OMC Layout Modification Plan

2019/8/7
Yoichi Aso

There are several problems with the current component layout of the OMC

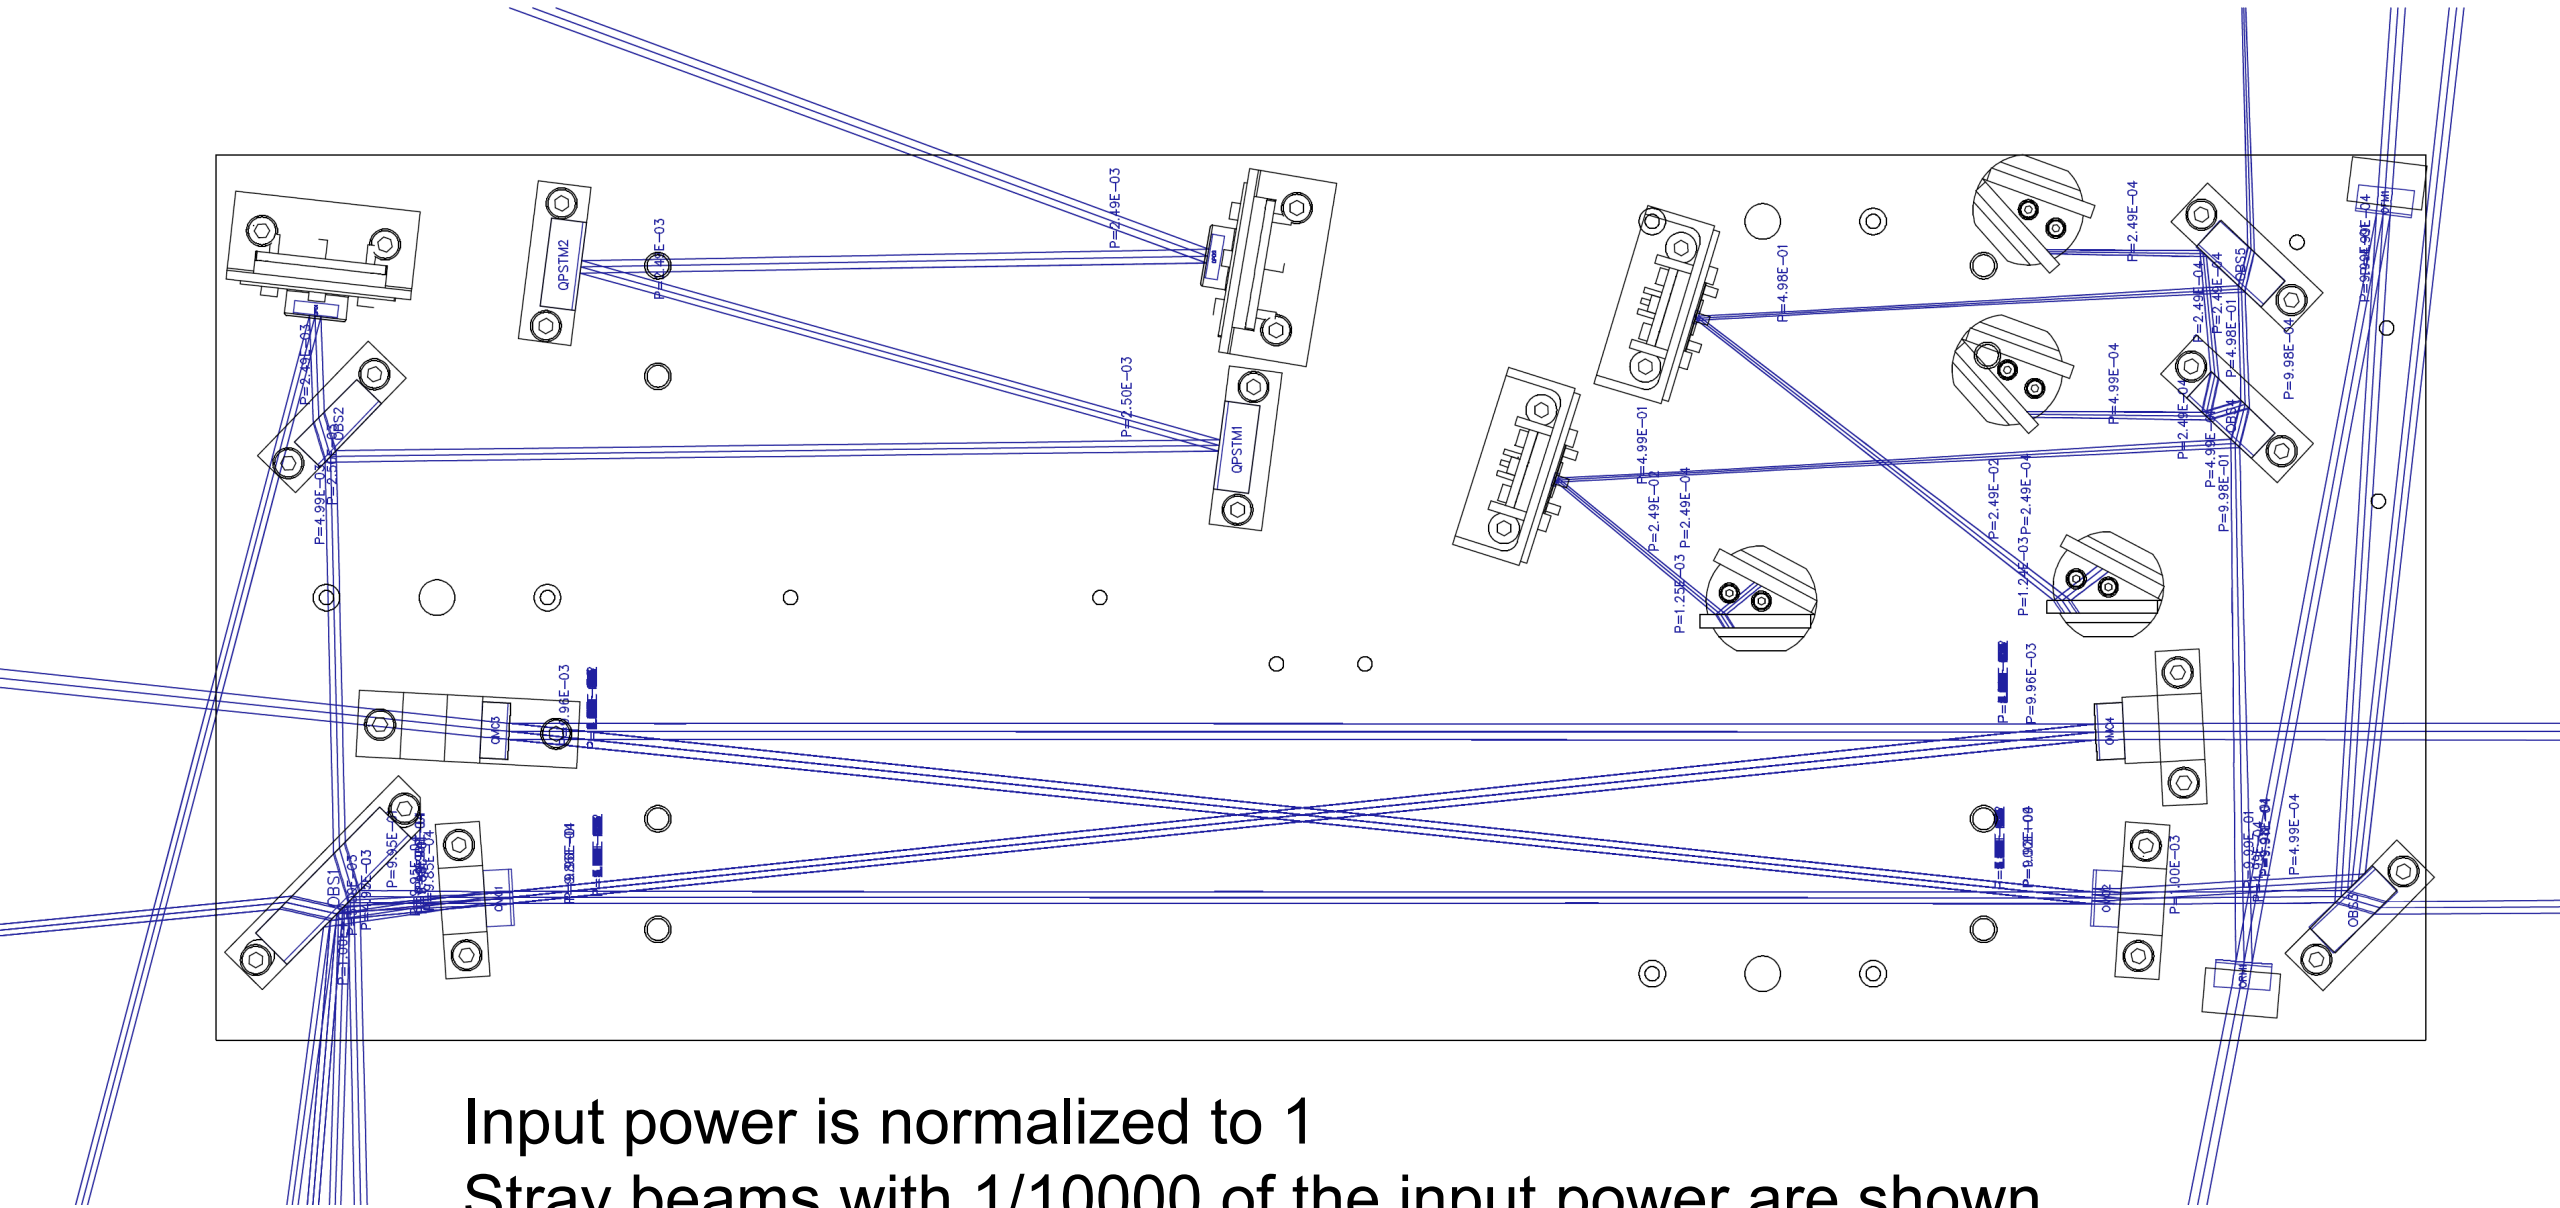
- OMC cavity axis does not go through the center of the mirrors
- The beam spot size on the DC PDs is too large
 - The aperture size is about the same as the 2.7σ diameter of the beam
- Ghost beams need to be dumped.

In order to cope with the above issues, I propose to modify the layout of the OMC as shown in the following pages.

Modification point 2: Add folding mirrors in the output path

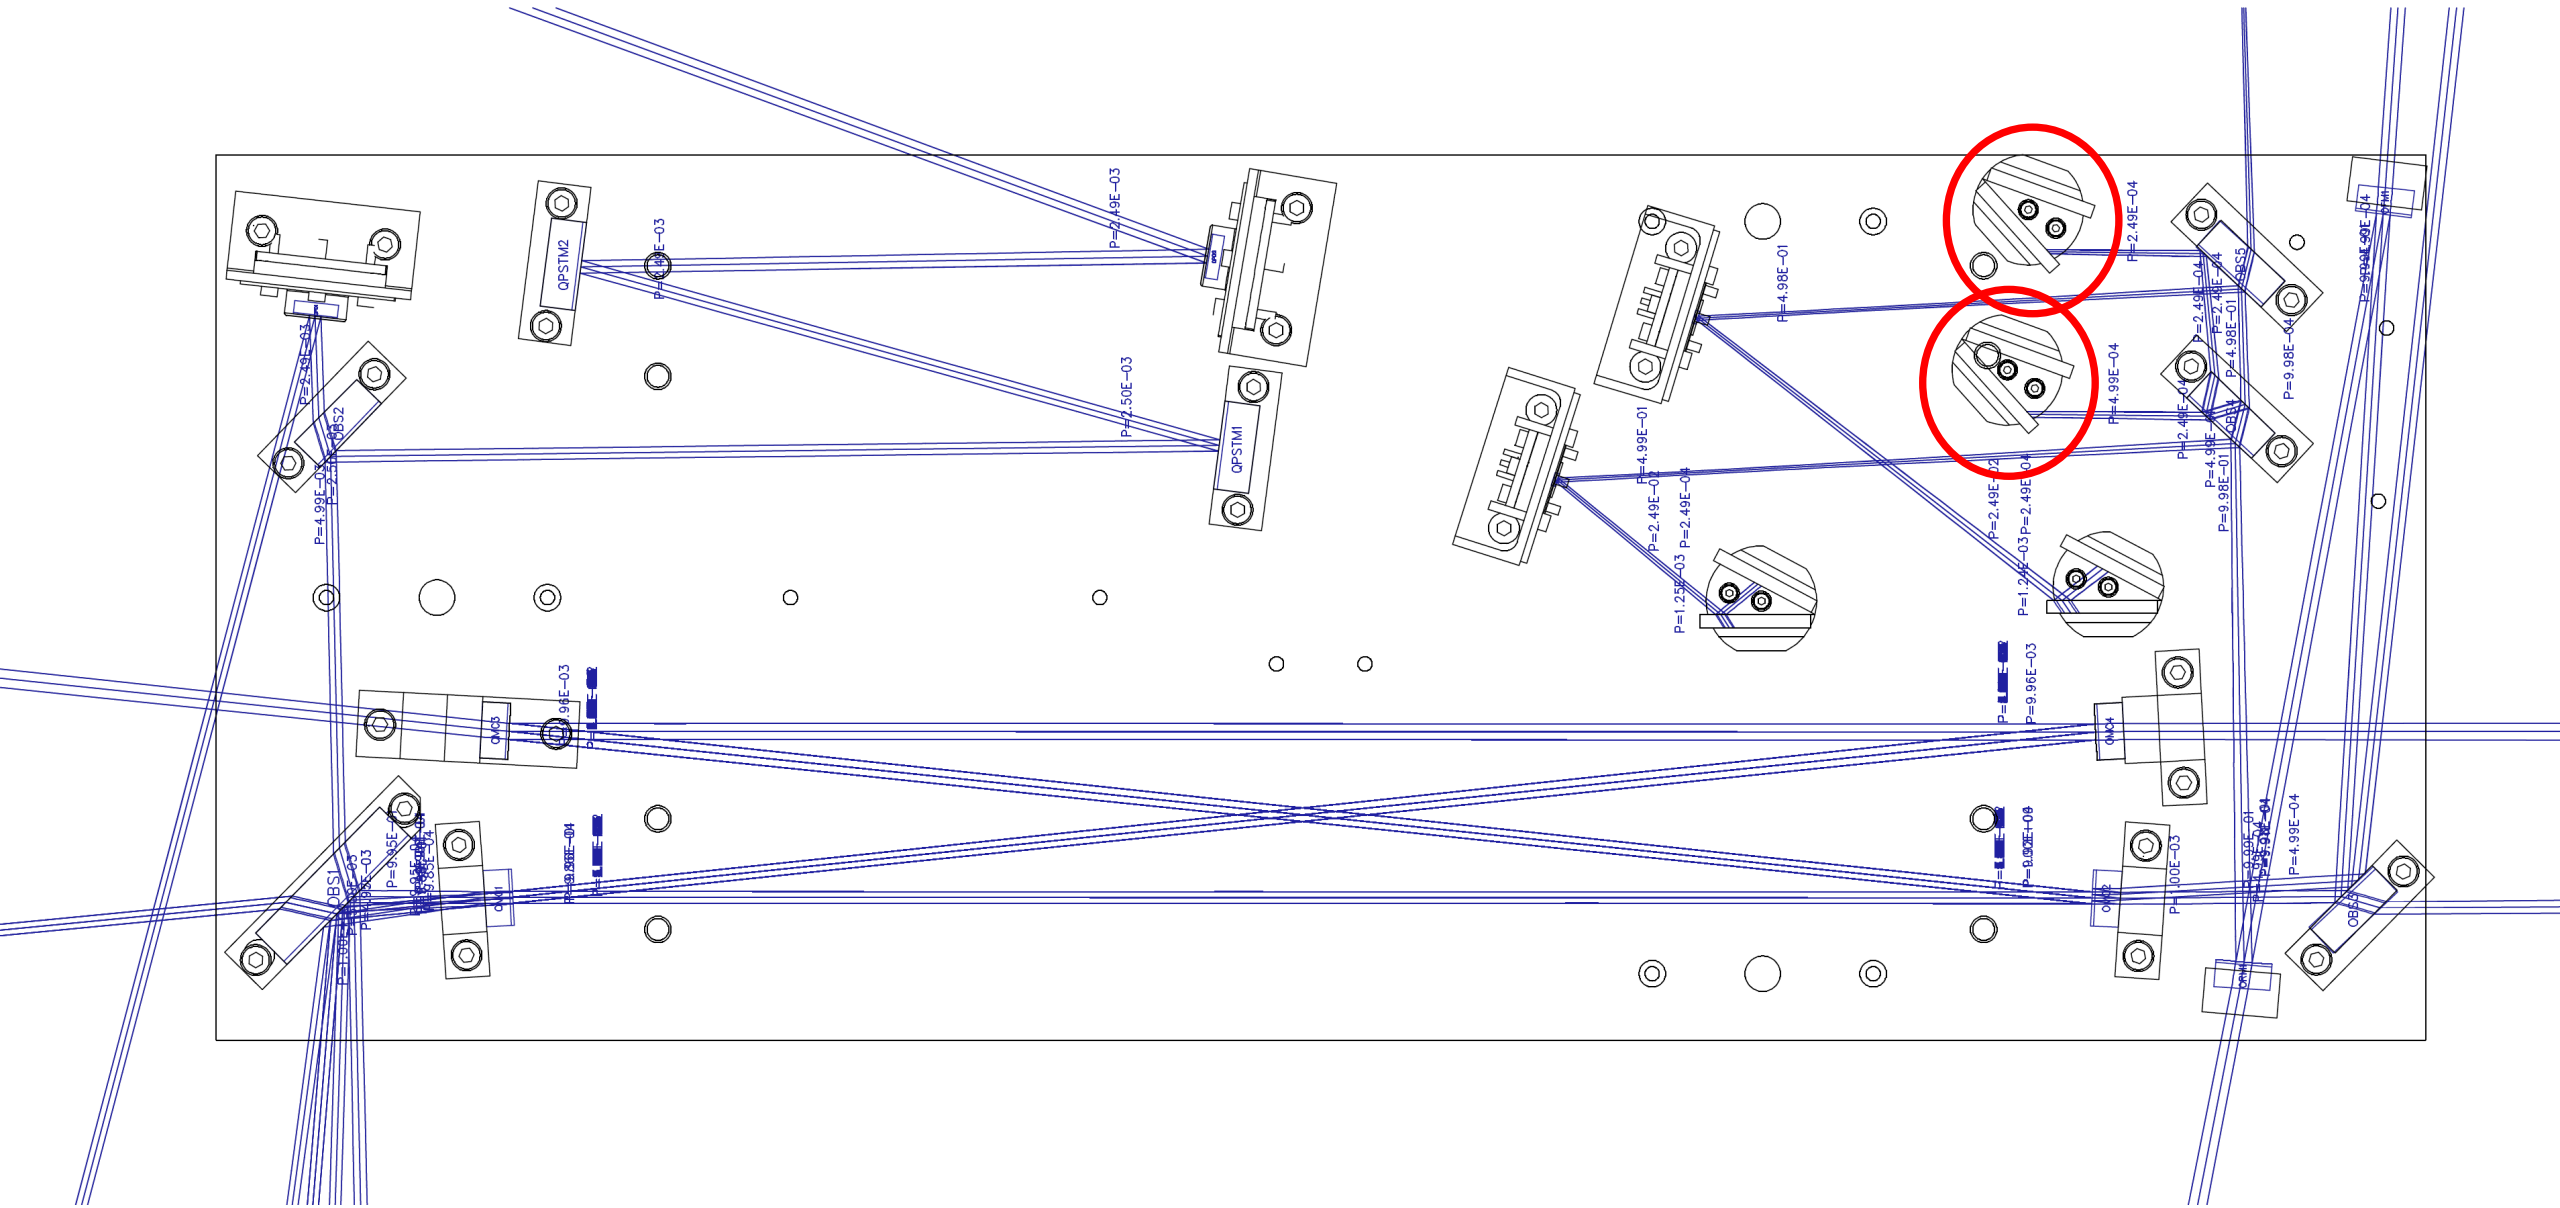
Explanation of the modification point 2

There is a possibility to make OBS3 curved. However, in this case, strong astigmatism is induced, due to the 45deg. AOI. This limits the achievable beam spot size to over 1.8mm (3sigma dia.)

Moreover, buying a curved mirror with 99.95% reflectivity for P-pol 45deg AOI may take some time (asking Layertec now).

Adding a curved mirror will make the beam spot size smaller at the DC PDs.
⇒ 3 sigma diameter will be less than 1mm

Normal incident high reflectivity mirror with R=500mm is available in stock from Layertec.

The folded layout does not induce strong astigmatism. Therefore, the achievable beam size is smaller.
